# Access Compliance Report

## Public Rights-of-Way

Intersection ID: 28165	Main Street: ARDREY_KELL_RD	Cross Street: LONGMONT_DR	Location: SW
ADA ID: FADF74089370	Ramp Type: Directional1	Initial Pass/Fail: Fail	Overall Compliance: No
Codes/Mitigation Info/Possible Solution		Field Measurements/Component Compliance	
Severity Score: 37.5

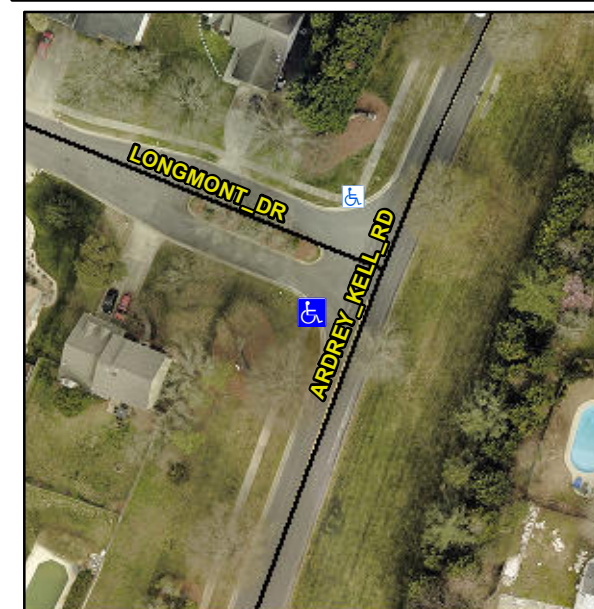
**Remove & Replace Entire Ramp.**

**R304.2.2, R304.5.3**
